# Addendum No. 1

**Date: October 5, 2018**

**Project: Nortrax Ottawa – 2<sup>nd</sup> Floor Office Fit Up  
190 David Manchester Road, Ottawa**

Coffee bar

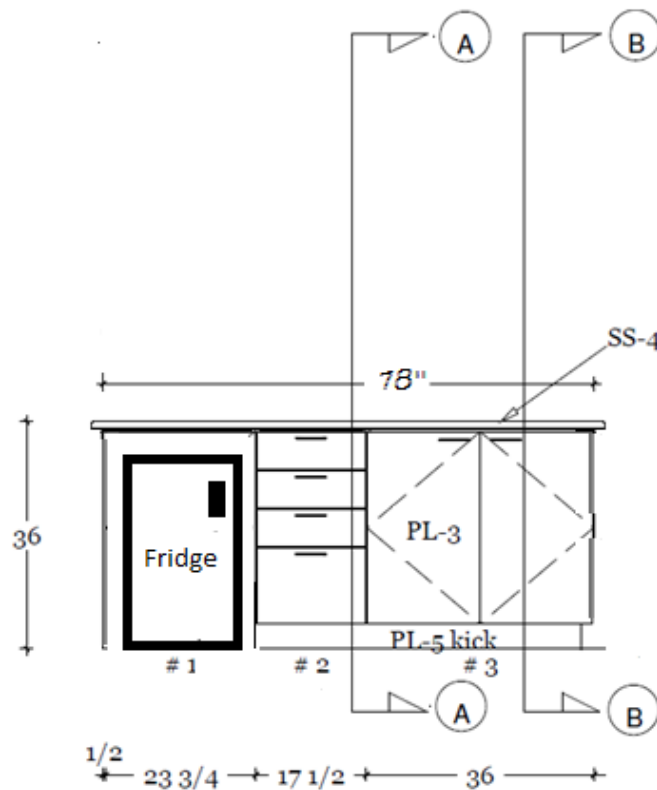
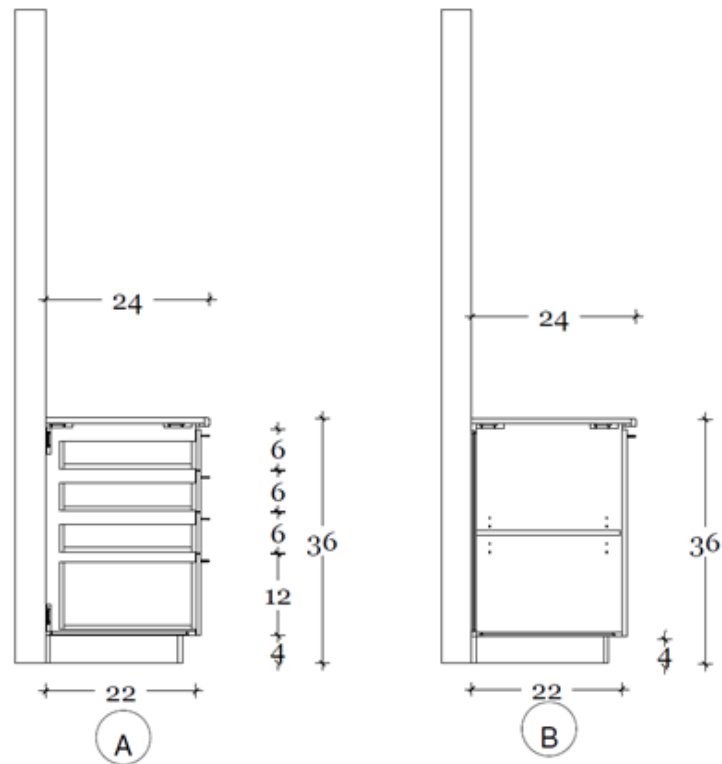
- 1.6 All ceiling tiles are to be CGC HALCYON CLIMAPLUS with rabbeted edges.
- 1.7 The ceiling in the 2<sup>nd</sup> floor conference room is dropped with suspended drywall and is inlaid with 2'x2' ceiling tiles.
- 1.8 Millwork details for the coffee station are provided below;

<p><b>PL-3</b> Wilsonart Cafelle #7933K07</p>  <p>Cabinets</p>	<p><b>PL-5</b> Wilsonart Black #1595-60</p>  <p>Toe Kicks / Inside Desks</p>	<p><b>SS-4</b> Corian Solid Surface Canvas</p>  <p>Work Surfaces</p>
---	---	--
